MILITARY SPECIFICATION

MICROCIRCUITS, DIGITAL, TTL, AND GATES,
MONOLITHIC SILICON

This amendment forms a part of Military Specification MIL-M-38510/16(USAF), dated 15 May 1973.

FIGURE 3. Schematic circuits for device type 02 - Continued. "

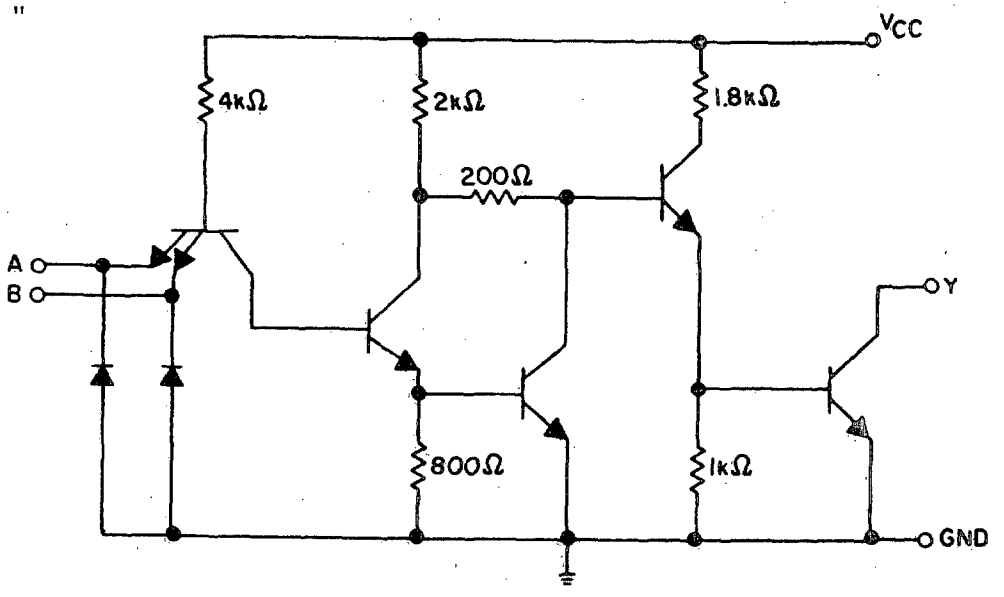
FIGURE 3, schematic circuit: Add new circuit "C" as follows:

SCHEMATIC C
